Docket Item # 9 & 10
BAR CASE # 2014-00032 & 00033

BAR Meeting
March 5, 2014

ISSUE: Partial Demolition/Capsulation and Certificate of Appropriateness for Alterations

LOCATION: 100 Quay Street

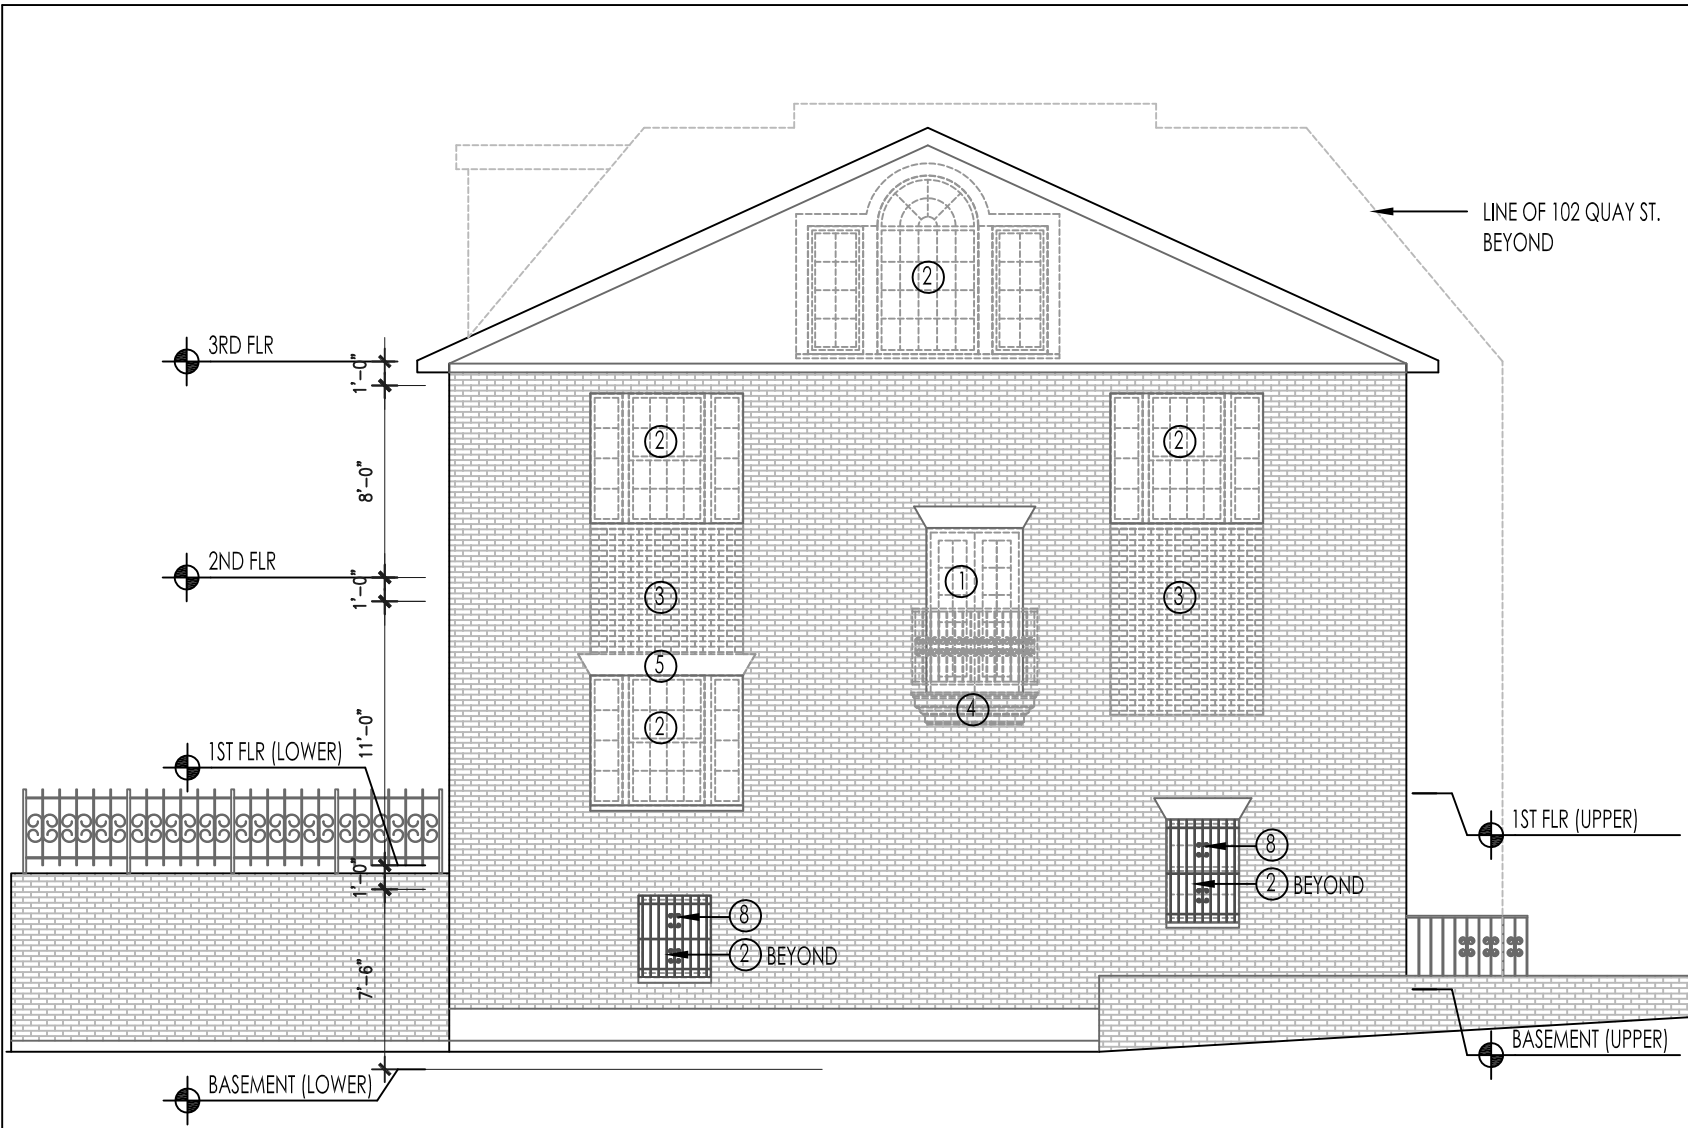
1. Enlarge the masonry opening around four windows to build a two-story projecting bay window with aluminum-clad wood windows in a contemporary design;
2. Replace the remaining windows and door with aluminum clad wood windows and doors to match those of the bay window; and
3. Replace the existing garage door with a new aluminum and frosted glass door.

Staff finds the present proposal to be very carefully studied and an enormous improvement over the random fenestration on the existing building. In particular, the Palladian window on the east façade, a perfectly understandable response to spectacular views of Founder's Park and the river from the fourth floor of this corner unit, is massively out of scale with the other windows on this highly visible elevation. Through numerous design studies, the architect has found a common proportion in the Colonial Revival tri-partite composition of the existing windows (a large center window with narrow sidelights on each side), simplified and applied that common window module throughout the project. The Palladian window now has a rectangular head so that it is not foreign to the other windows on this elevation. The sizes of other windows have been regularized to the extent possible on the existing structure. A two story bay window, similar to others found in this development, also utilizes the same window type.

EAST ELEVATION - PROPOSED MODIFICATIONS

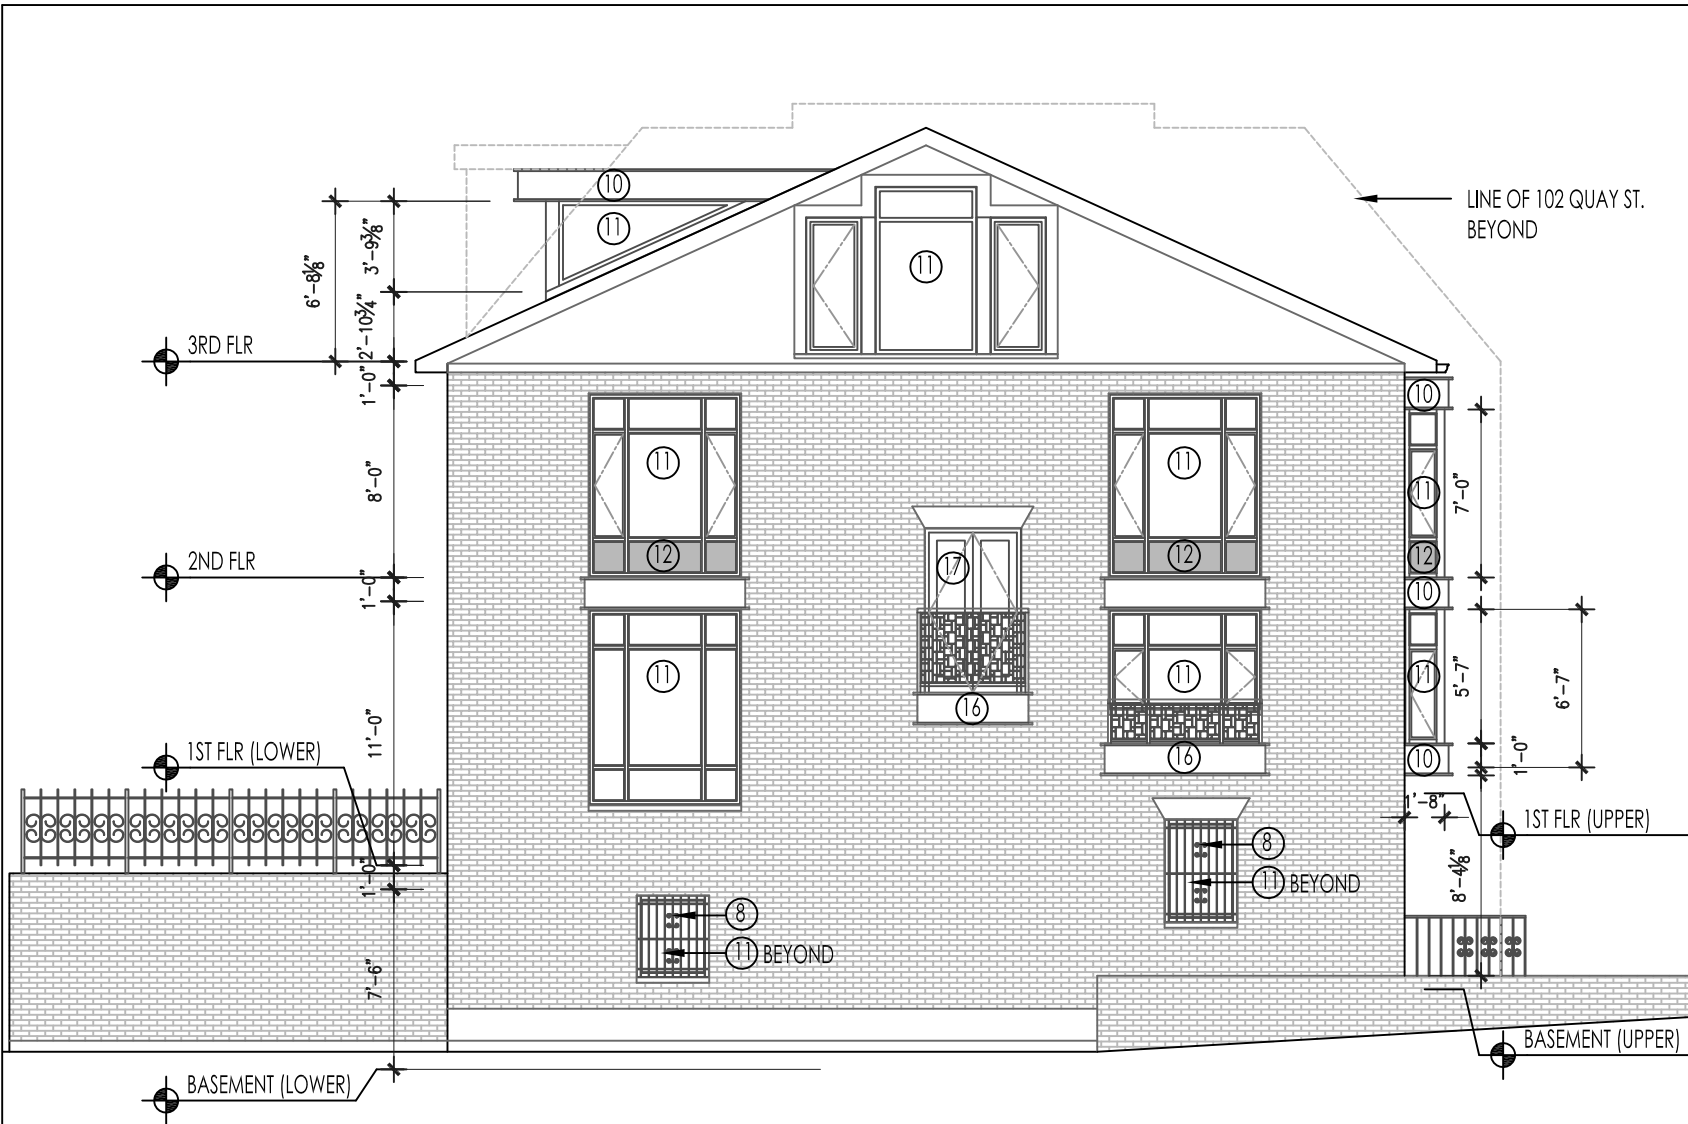
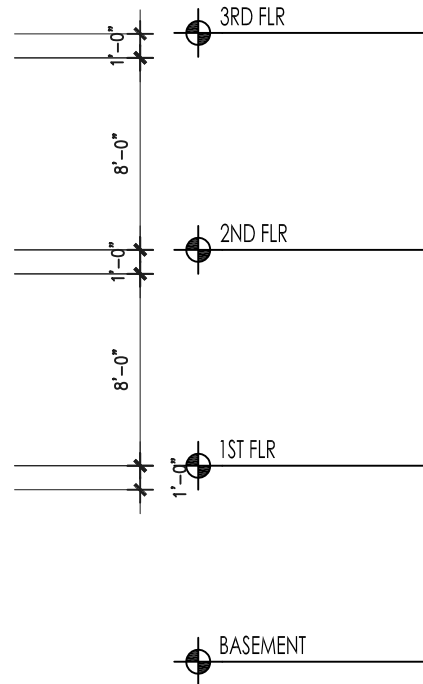
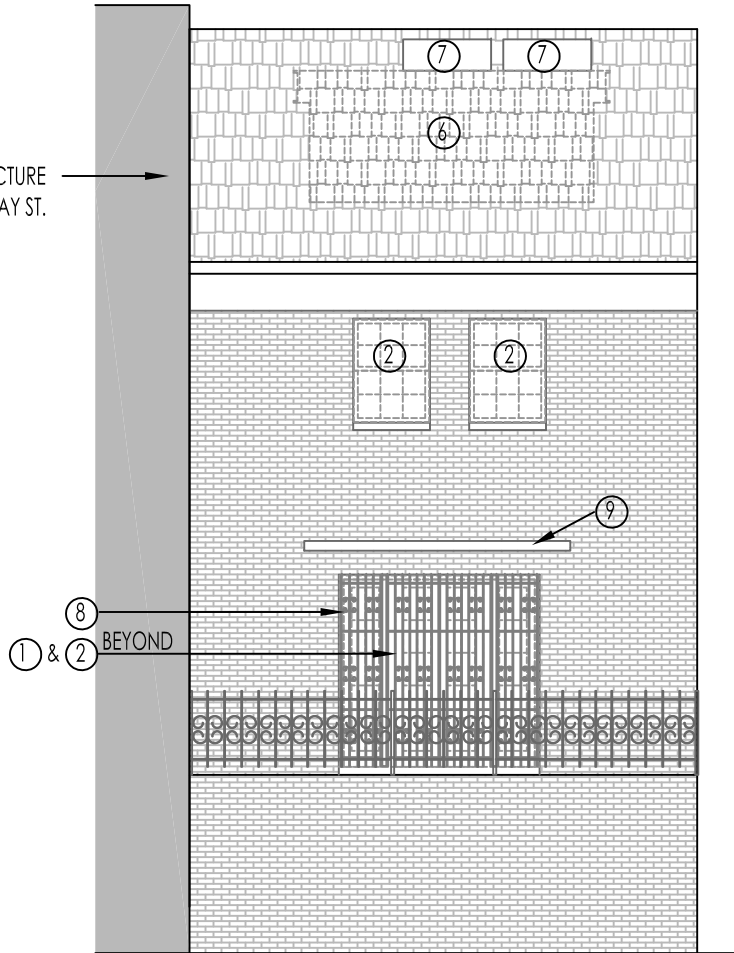
1. Enlarge three existing window openings to accommodate a pair of two-story projecting bays;
2. Replace the remaining windows and door with aluminum clad wood windows and doors to match those of the bay windows;
3. Modify the existing third floor Palladian window; and
4. Replace the Juliette balcony and flower boxes with a new rail and decorative flower boxes.

PROPOSED SOUTH ELEVATION

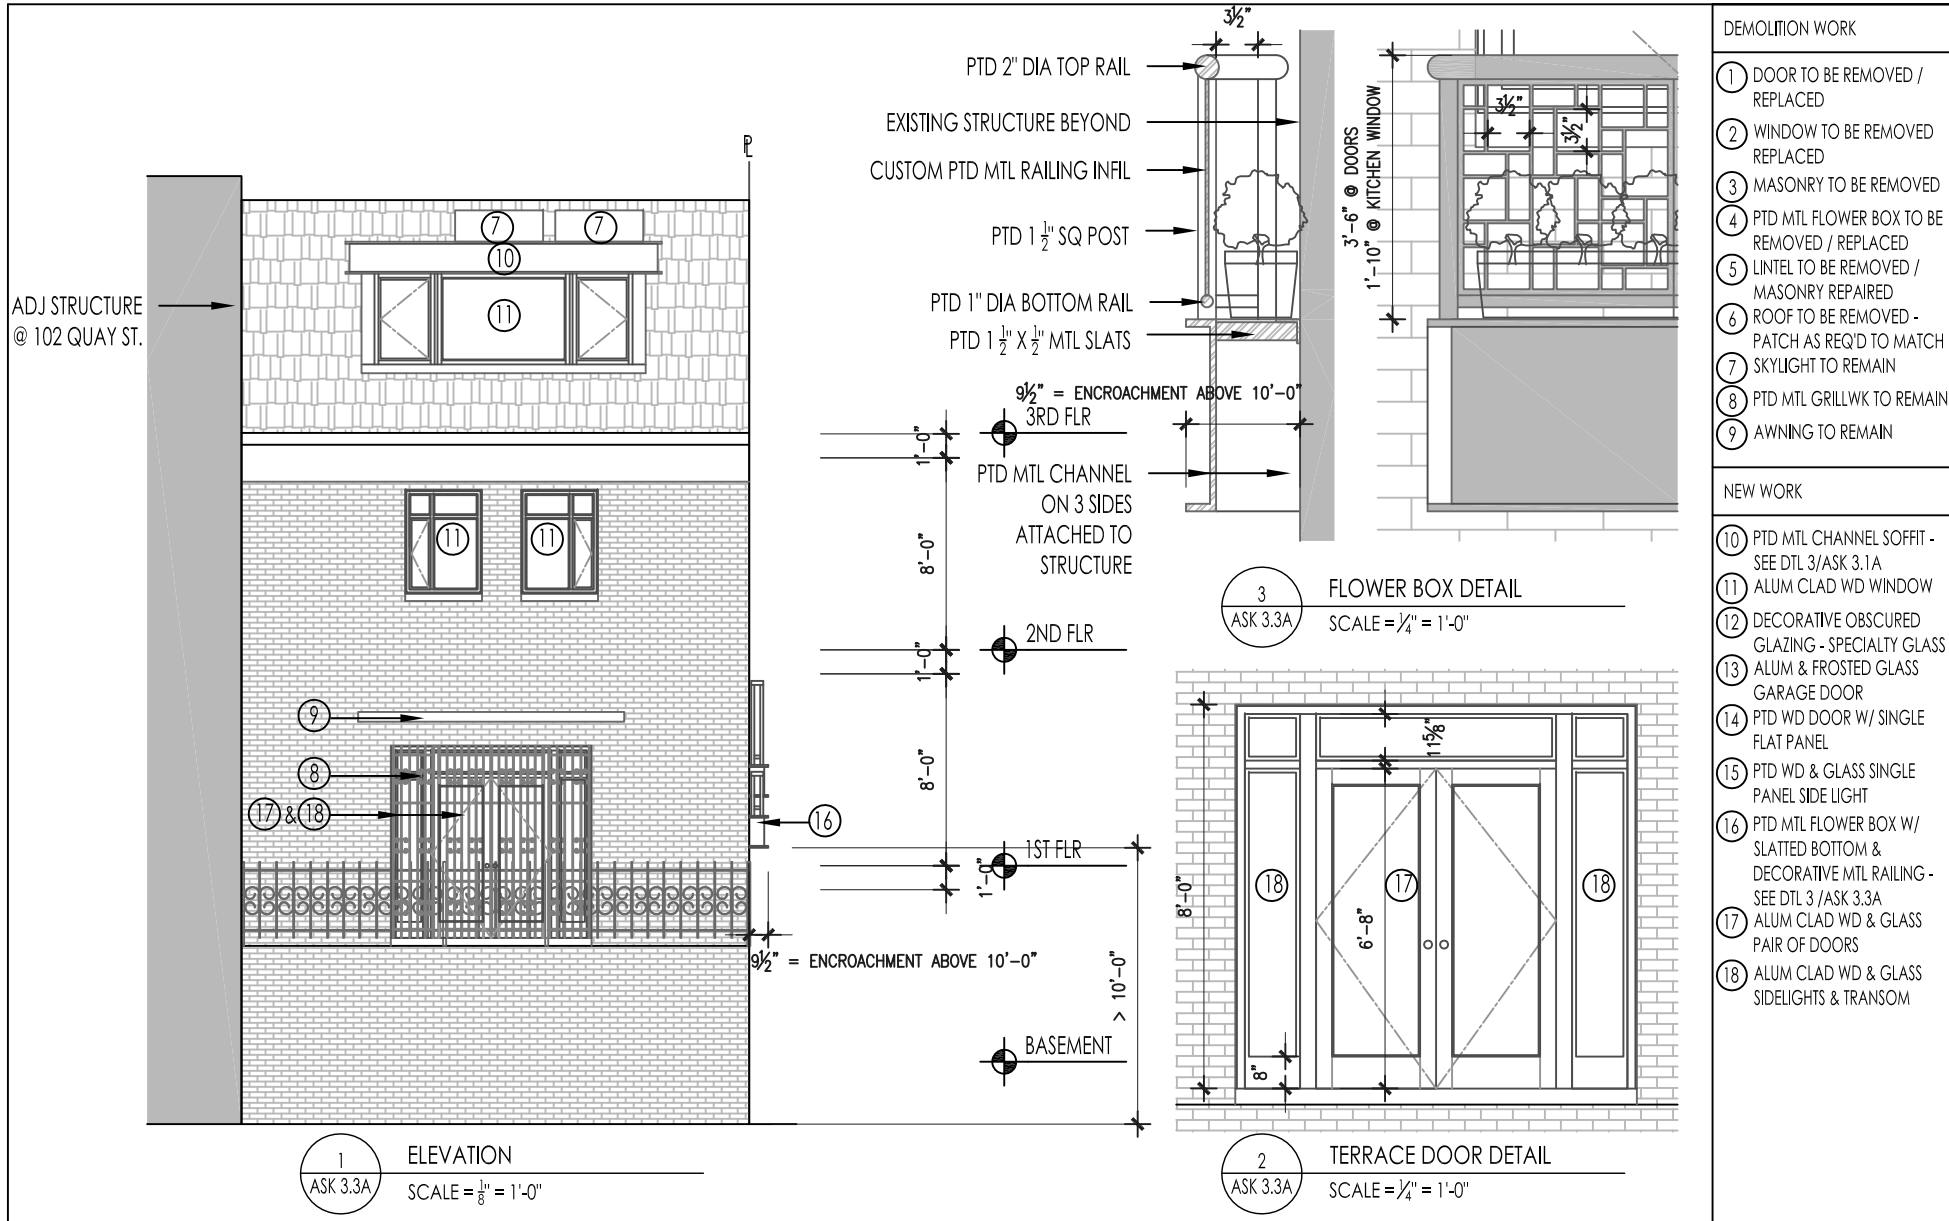
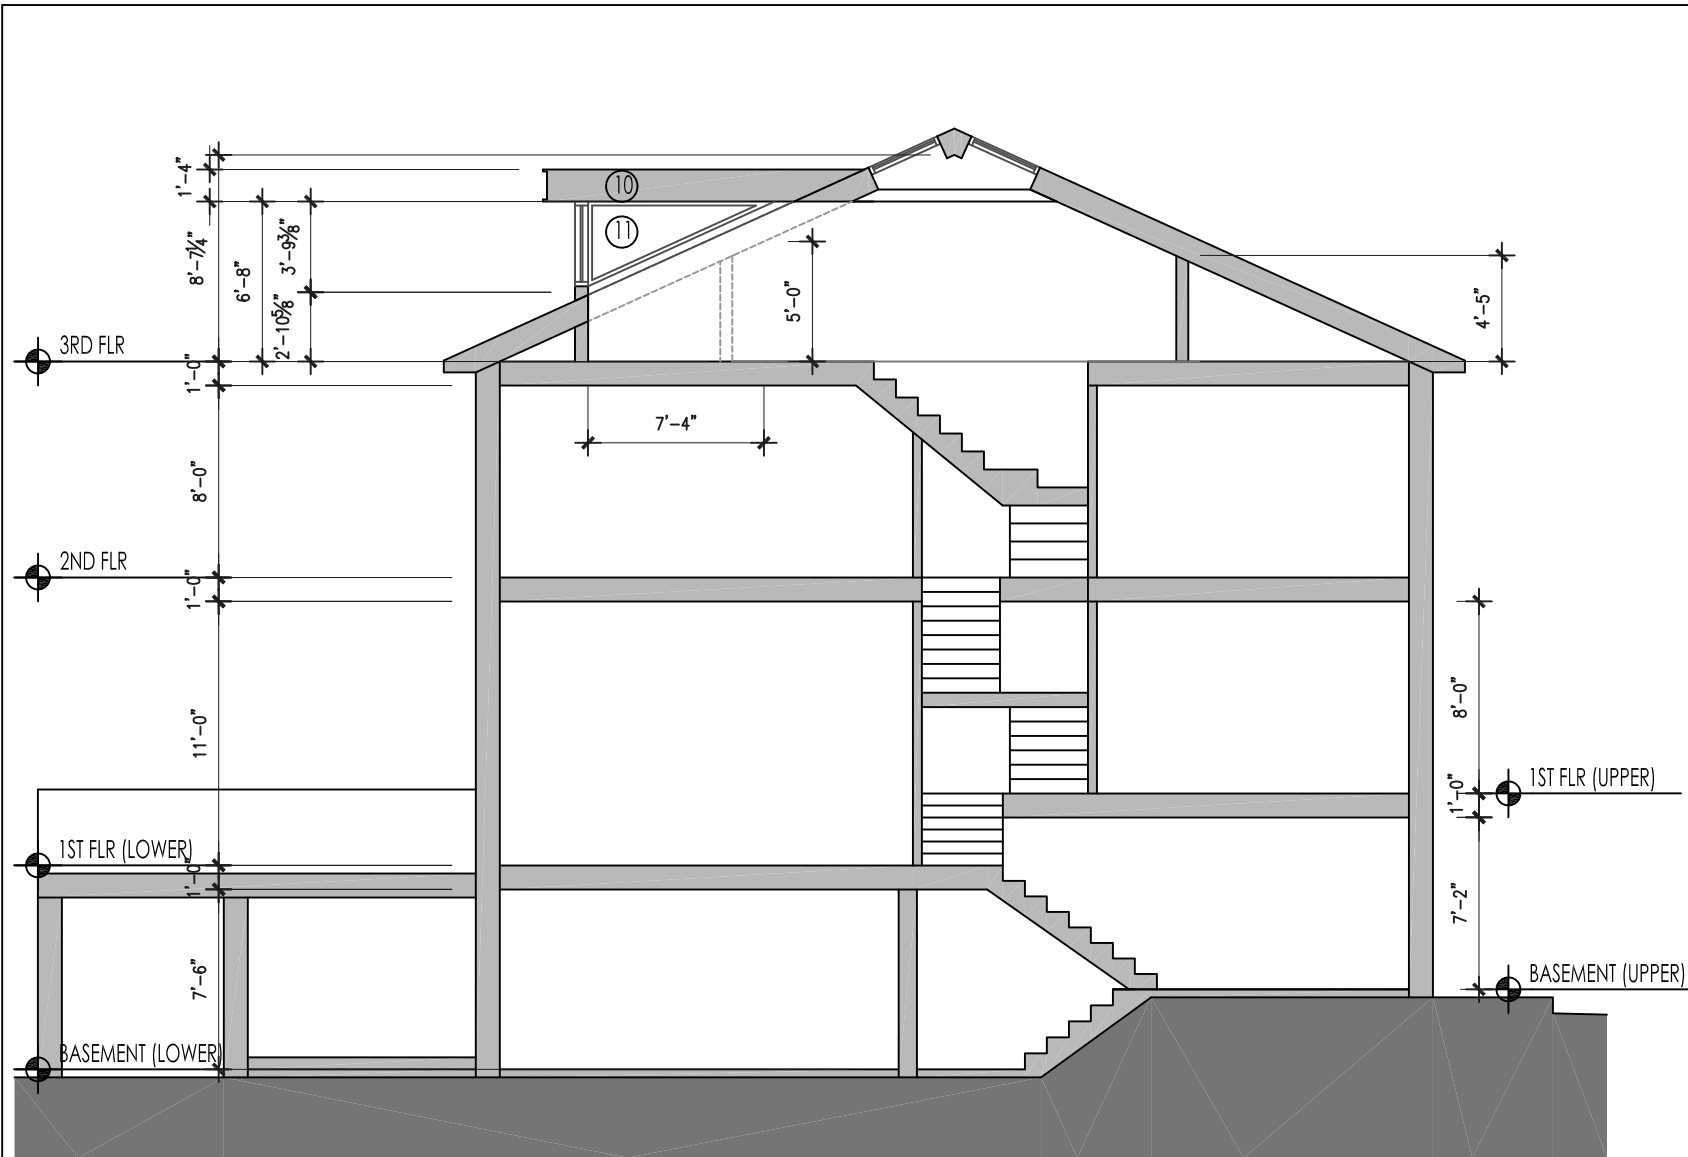
1. Add a flat-roof dormer (described as "rooftop embellishment" in the plans) featuring an aluminum clad wood window; and,
2. Replace existing windows and door with materials and style identical to other proposed changes.

The *Design Guidelines* also state that dormers must be proportionate and appropriately centered on structures, with sash and trim that matches other window types on the existing building. The proposed dormer detailing is coordinated with the other proposed window replacements. Dormers have routinely been approved on the rear of townhouses in this development and, although the rear of this corner house is more visible than those on the interior of the block, the dormer design is appropriate for this unit.
